NEW 4 RING STATOR	4
NEW LIP SEALS	8
NEW PARKING GUIDE BRACKET AND PARKING PAWL	10
NEW TRANSAXLE CONTROLLER AND LOCATIONS	12
NEW BELL HOUSING BOLT PATTERNS	15
NEW 4 DISC OVERDRIVE CLUTCH ASSEMBLY	20
NEW PRNODL AND NEUTRAL SAFETY SWITCHES	26
NEW GEAR RATIOS AND IDENTIFICATION	28
NEW (5TH DESIGN) TRANSAXLE CONTROLLER	32
NEW 1990 1/4 OVERDRIVE/REVERSE PISTON	33
NEW 1990 1/4 INPUT CLUTCH HUB	38
2/4 AND L/R CLUTCH PACKS (ASSEMBLY TIP)	42
PREMATURE FAILURE OF O.D. AND REVERSE CLUTCHES	45
FAULT CODES	46
FAULT CODE EXPLANATION	47
DIAGNOSTIC CONNECTOR LOCATION	72

AUTOMATIC TRANSMISSION SERVICE GROUP

Chrysler A604

Figure 1

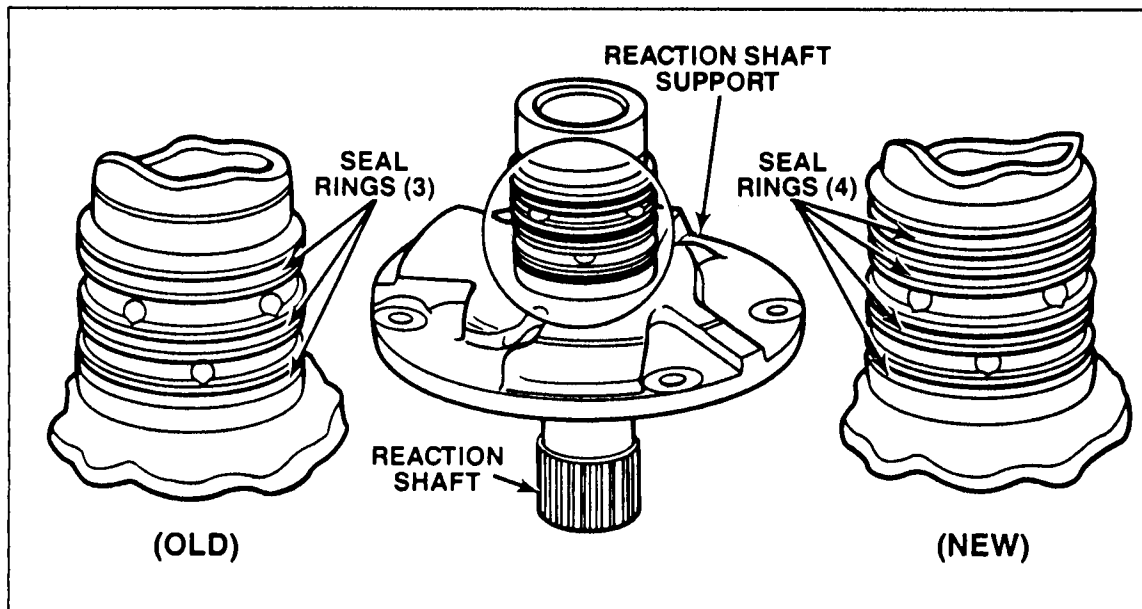
CHANGE: Beginning in April, 1989 a new Reaction Shaft Support (Stator) was introduced, with the addition of another ring groove and sealing ring. The old support has 3 sealing rings, and the new support has 4 sealing rings (See Figure 1).

- (1) REACTION SHAFT SUPPORT - The new support is longer, and has 4 sealing rings, where the old support only has three (See Figure 1).
- (2) INPUT SHAFT/CLUTCH HUB - The new Input Clutch Hub bore is machined deeper to accommodate the additional length of the reaction shaft, created by the added sealing ring (See Figure 2).
The "O" Ring grooves are also cut shallower than the old input clutch hub, which increases the groove diameter, and provides improved compression or "Crush", between the "O" rings and the input clutch retainer. (See Figure 2).

ALWAYS UPDATE to the four ring reaction shaft support. There is now available a repair package, OEM part number 4549248, that includes the following:

Figure 2

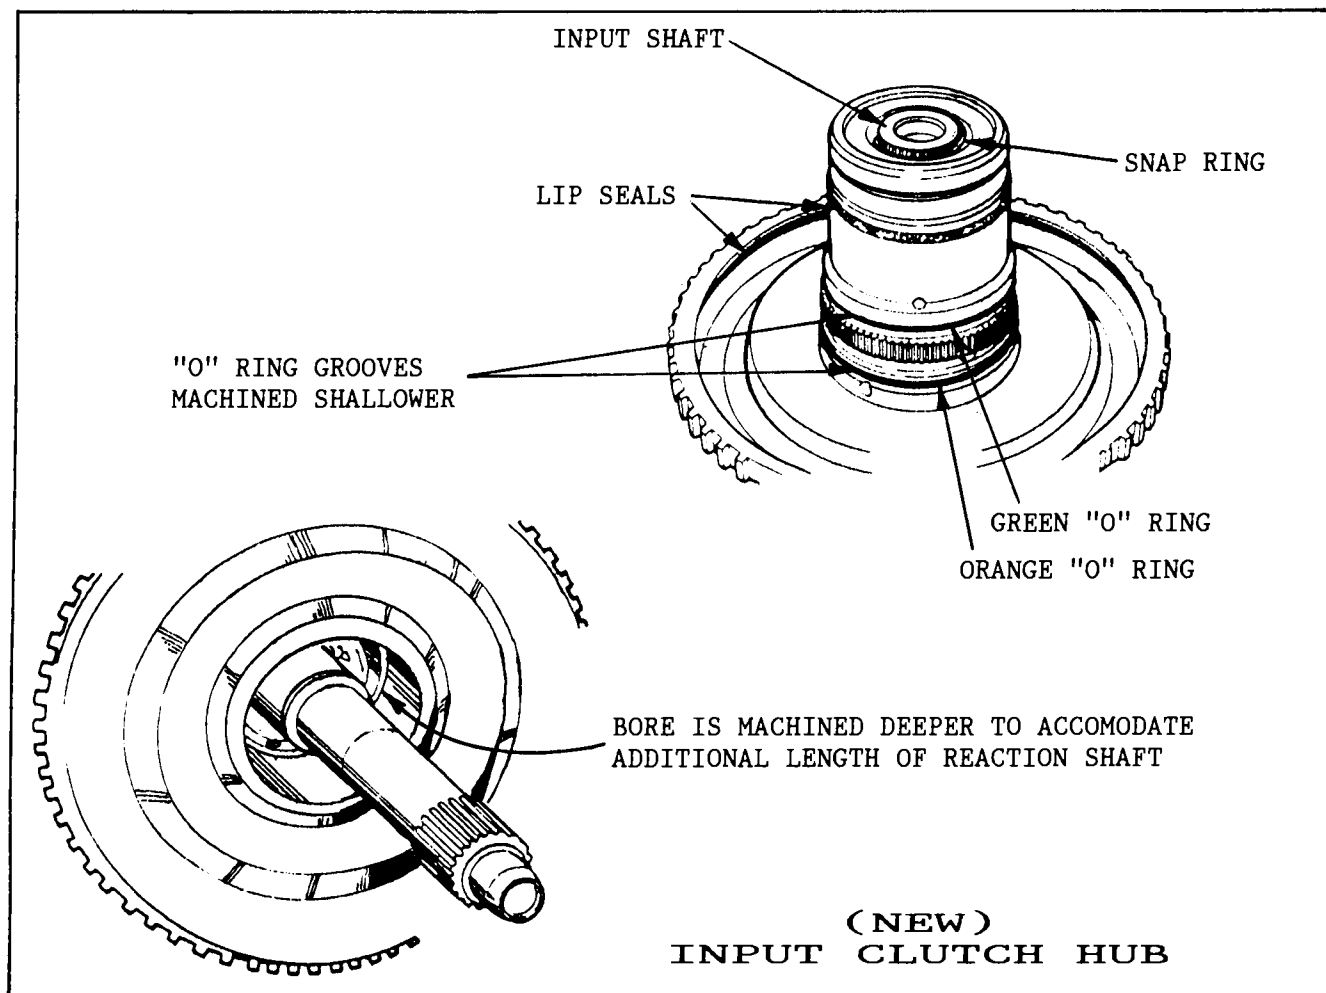
- (3) INPUT SHAFT/CLUTCH HUB "O" RINGS - The new "O" Rings are "Teflon Coated" for greater tear resistance during the assembly process. The coatings also identify the locations for the "O" Rings. The orange ring goes to the front, and the green one goes to the rear (See Figure 2). The early "O" rings were black.

Figure 3

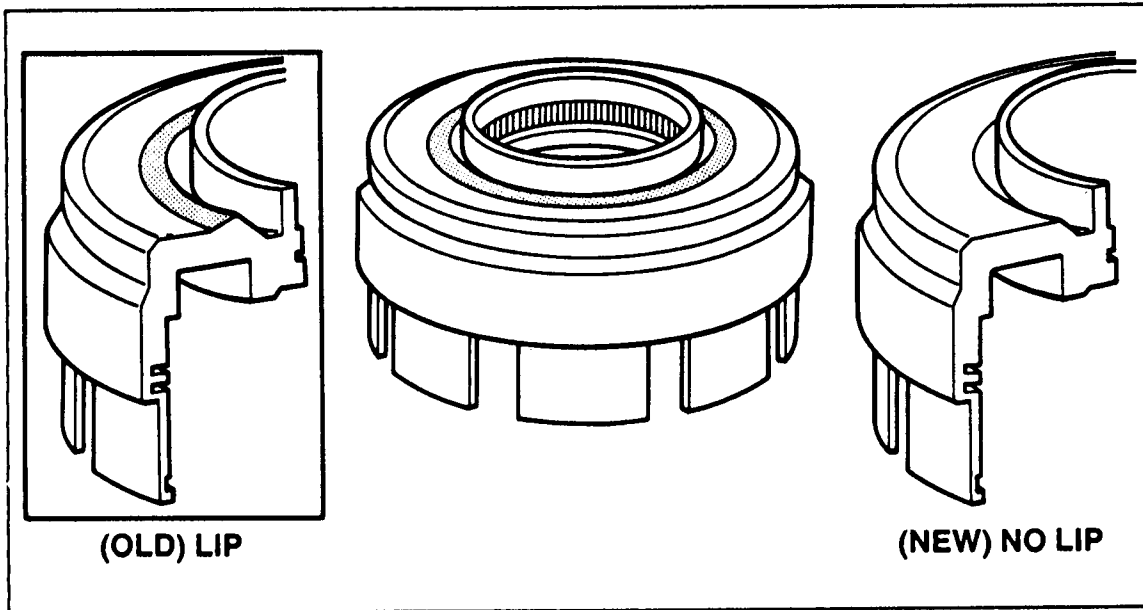
- (4) INPUT CLUTCH RETAINER - The Input Clutch Retainer was modified, by machining off the "Lip" (See Figure 3), to allow more travel of the overdrive/reverse piston. The old Input Clutch Retainer can be machined at the local machine shop if necessary.

Figure 4

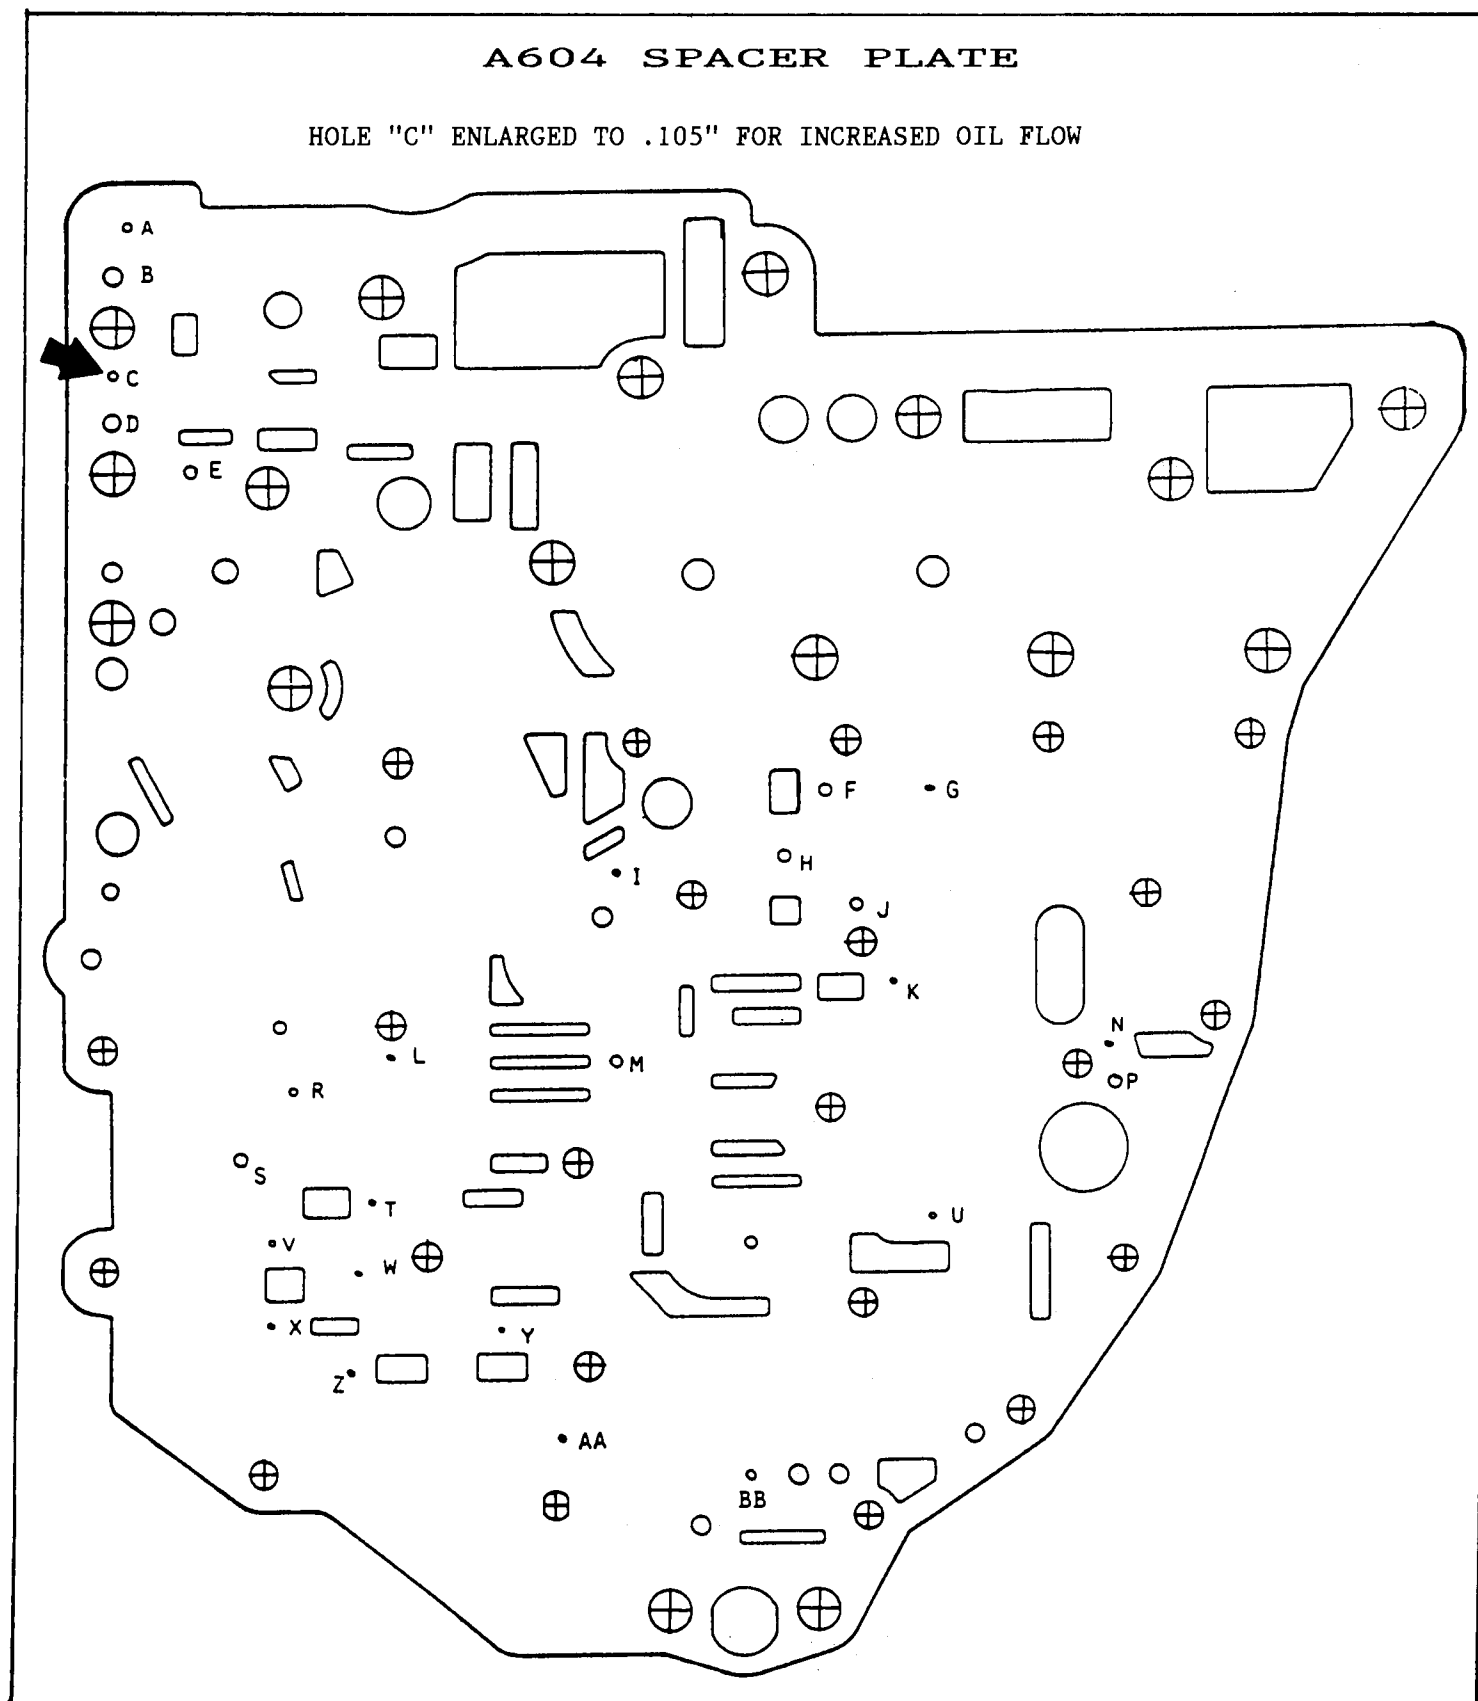
- (5) SPACER PLATE - The new Spacer Plate has a larger (.105") overdrive clutch feed orifice to provide increased oil flow to the overdrive clutch circuit (See Figure 4).

Figure 5

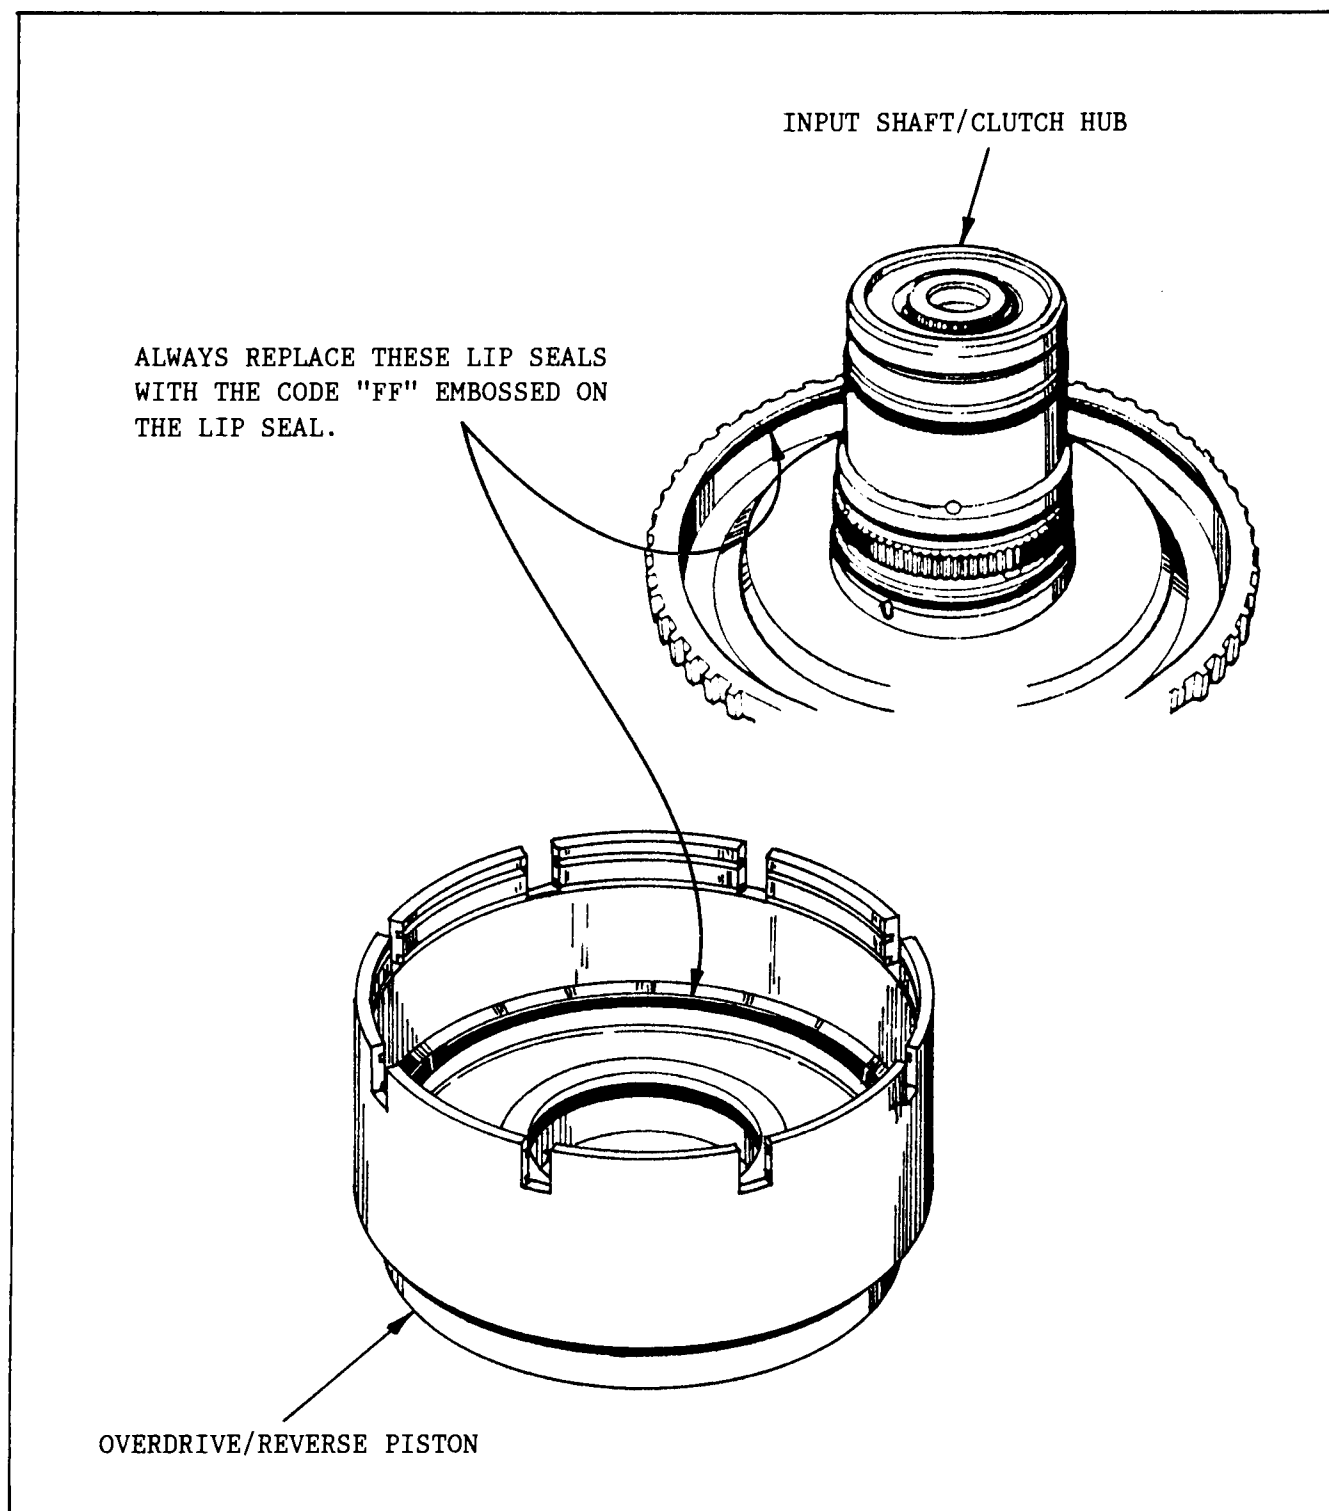
CHANGE: The lip seals in the Overdrive/Reverse Clutch Piston and the Input Shaft/Clutch Hub are now replaced with lip seals made of different material (See Figure 5).

- (1) OD/REVERSE PISTON LIP SEAL - No dimensional changes, but the material changes, and the new lip seals can be identified by the code "FF" embossed into the seal. The old lip seal is embossed with the code "IPC", and should not be used (See Figure 5).
- (2) INPUT CLUTCH HUB OUTER LIP SEAL - No dimensional changes, but the material changes, and the new lip seals can be identified by the code "FF" embossed into the seal. The old lip seal is embossed with the code "IPC", and should not be used (See Figure 5).

THE NEW LIP SEALS EMBOSSED WITH THE CODE "FF" WILL RETRO-FIT BACK TO ALL PREVIOUS MODELS, AND SHOULD BE USED DURING OVERHAUL.

Figure 6

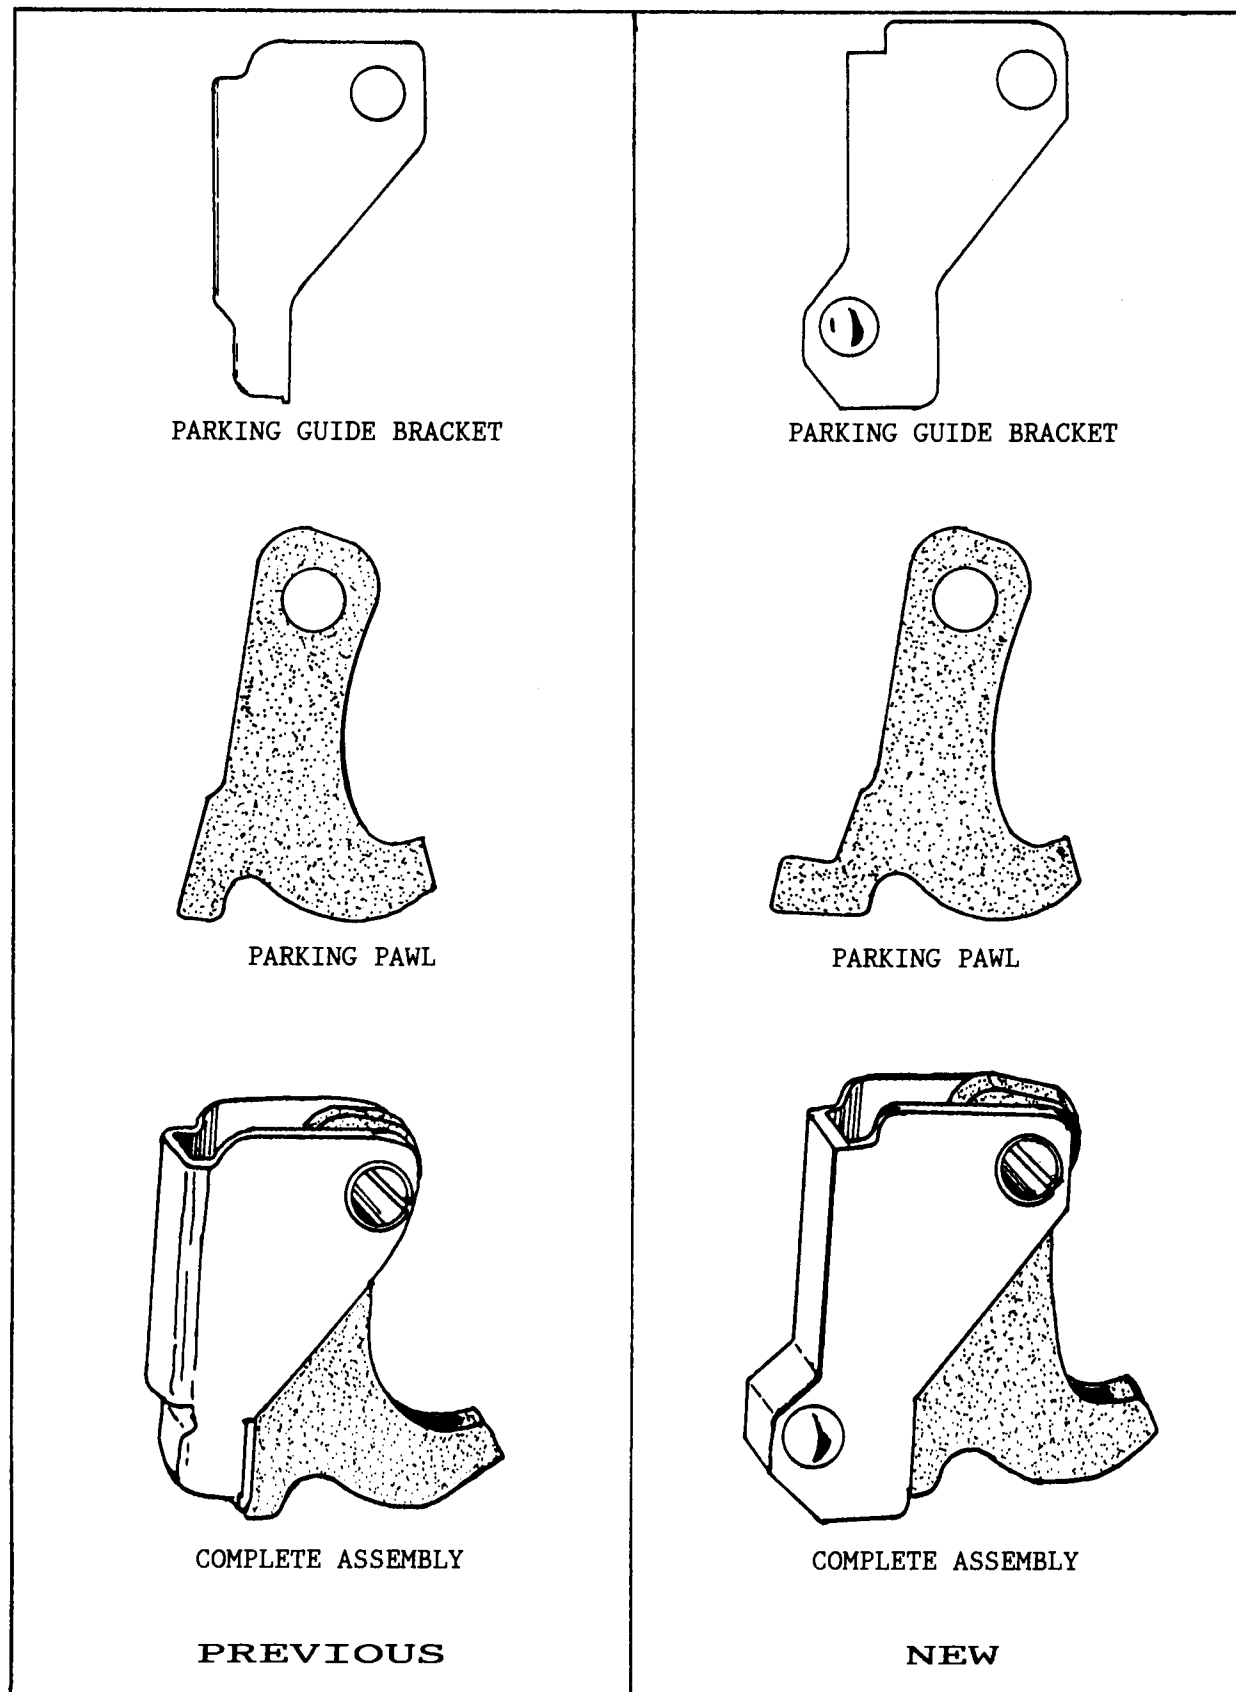
CHANGE: A new Parking Sprag Guide Bracket and Parking Pawl has been introduced as a 1989 running change (See Figure 6).

- (1) **PARKING GUIDE BRACKET** - Previously the Parking Guide Bracket was a stamped steel unit, and has been replaced by a high quality casting, along with dimensional changes. See Figure 6 for identification.
- (2) **PARKING PAWL** - The new Parking Pawl, or "Boot", also required some dimensional changes. The heel of the new "Boot" is wider than the previous models, as shown in Figure 6.

The new parts will retro-fit back to all previous models, but both pieces must be replaced as an assembly. (See Figure 6).
